Proposal for amendments to ECE/TRANS/WP.29/GRSG/2019/33

I. Proposal

Paragraph 7.1.3.3., amend to read:

“7.1.3.3. Determination of the Test Areas for Category 1-2 and 2 Vehicles using the "O" Point

Figure 4
Determination of Zone I

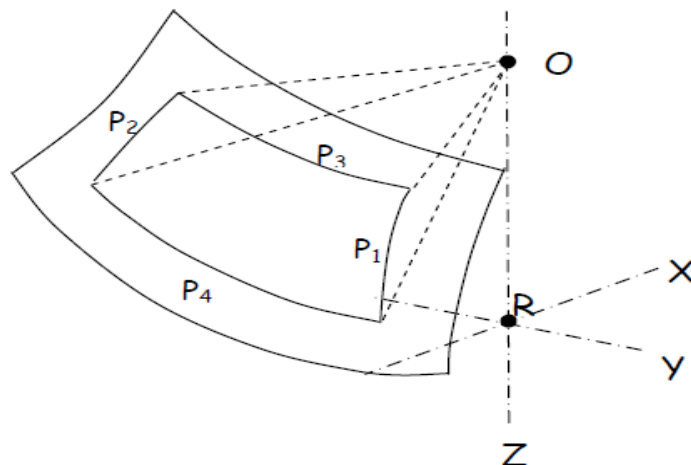
7.1.3.3.2. Zone I is the zone determined by the intersection of the windscreen with the four planes defined below:

In addition, opaque obscuration can be exempted in Zone I. It is the limited areas where it is intended that a sensing device, e.g. a rain-drop detector, rear view mirror or autonomous sensors, will be bonded to the inner side of the windscreen. The opaque obscuration where such devices may be applied is defined in paragraph 7.1.3.3.3. of this annex.

P1 a vertical plane passing through [point O](#) and forming an angle of 15° to the left of the median longitudinal plane of the vehicle;

P2 a vertical plane symmetrical to P1 about the median longitudinal plane of the vehicle.

P3 a plane passing through a transverse horizontal line containing O and forming an angle of 10° above the horizontal plane;

P4 a plane passing through a transverse horizontal line containing O and forming an angle of 8° below the horizontal plane;

Figure 4(a)

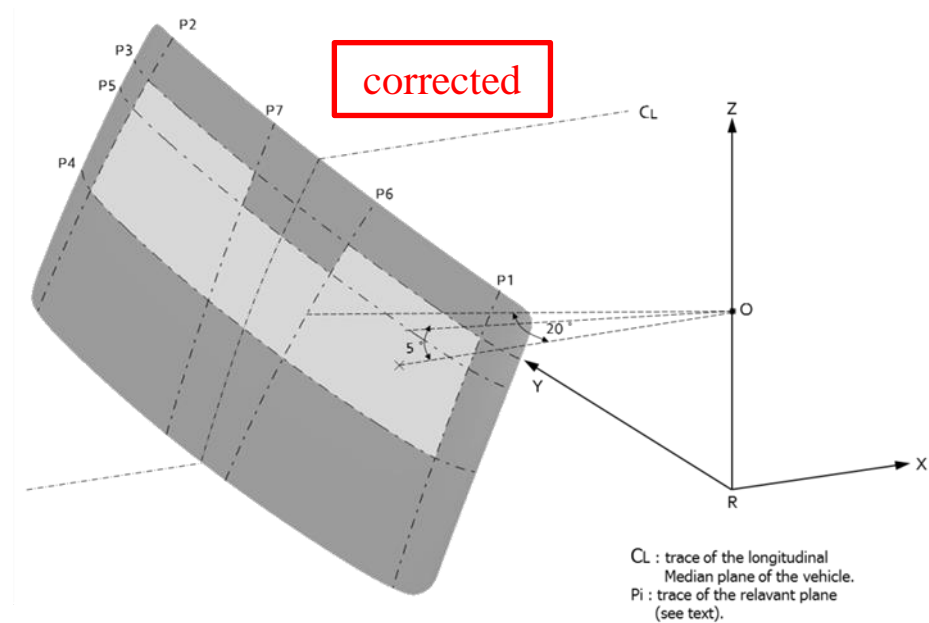
~~7.1.3.3.3.1. At the discretion of the vehicle manufacturer, one of the two following paragraphs may apply: (See Figure 4(a) or Figure 4(b))~~

7.1.3.3.3.1. Any opaque obscuration bounded downwards by P5 and laterally by P6 and P7; (See Figure 4(a))

1. In the case of open type loadings tray in trucks, interior mirror application is required to secure rear view.
2. Various safety and convenience options (Lane Departure Warning Systems (LDWS), Autonomous sensors, etc.) for trucks are being installed or under development. If these options are fitted on the underside dashboard-top of the windshield glass, it may limit the driver's direct front of vision (with potential negative consequences to safety).

3. For the optimization of installation, the above options may be integrated with the interior mirror. However it is difficult for some models to install the interior mirror, since Zone I may be intruded. Therefore, the opaque obscuration which can be used for installation of the above safety and convenience options must be permitted additionally. For this reason, some new planes such as P5, P6, and P7 shall be added.

4. On the other hand, the new opaque obscuration for Category 1-2 and 2 Vehicles has to be equal level with the one for Category 1-1 vehicles using the "V" points in order not to violate safety. So the Republic of Korea proposes the 5° above to determine the P5.

Figure 4(b)

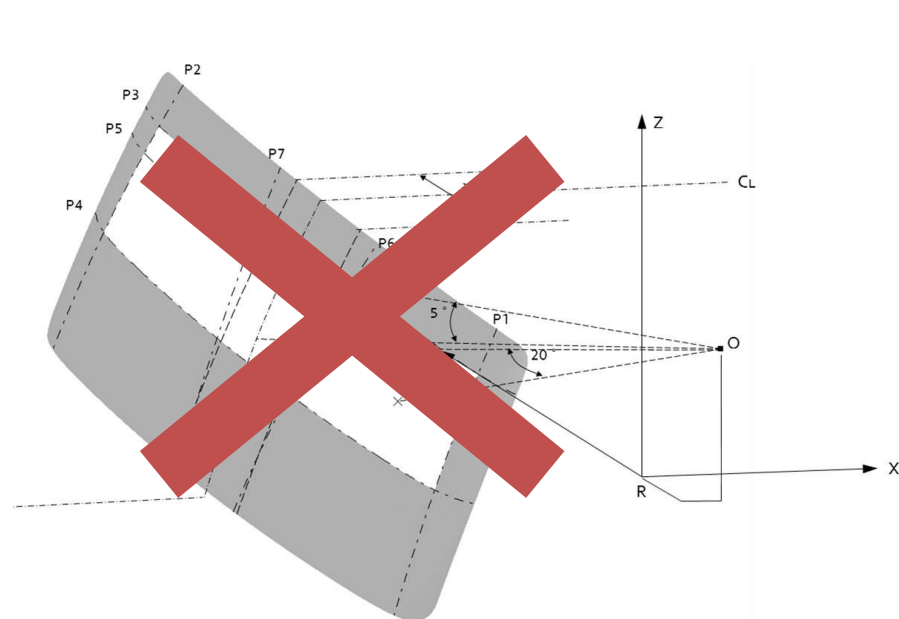
~~7.1.3.3.3.1.2. Any opaque obscuration bounded downwards by P5, provided it is inscribed in an area 300 mm wide centred on the longitudinal median plane of the vehicle.~~
